SAFETY RECALL

Volvo Trucks North America

Date	Number	Release	Page
02. 2024	RVXX2312	01	1(8)

Volvo Passenger Side Bench Seat VHD, VN

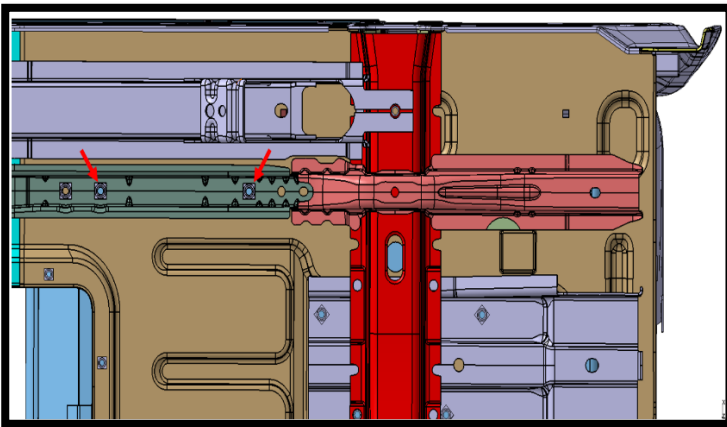
The passenger side bench seat attachment does not meet strength requirements due to inadequate floor reinforcement. In the event of an accident, the passenger bench seat attachment to the floor could fail, increasing the risk of injury.

8. Locate the two weld nuts in the channel.

9. Remove the two weld nuts using an air hammer and chisel or equivalent.

10. Once the weld nuts are removed, use a small hammer to flatten the metal back out where the nuts were secured to the reinforcement.

To ensure the safety of these vehicle, follow the instructions outlined below to remove the passenger seat mounting weld nuts and replace with the fabricated flange nuts/washers supplied in the kit.
